Briefing Notes

**ITEM 01 – The Hambrough Tavern, The Broadway, Southall**

## Planning Committee: 01.11.2023

**Amendment to Figure 47 (Basement Plan) of the Committee Report**

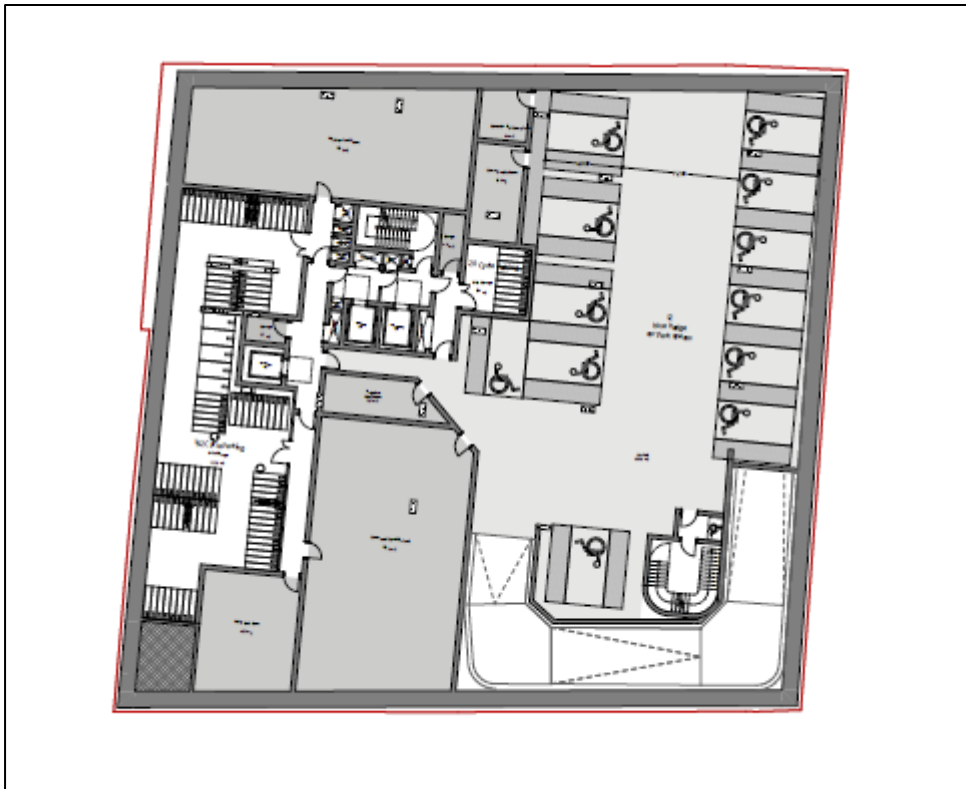
An incorrect version of the Basement Plan has been provided within the Committee Report. The image of the Basement Plan should be as follows:
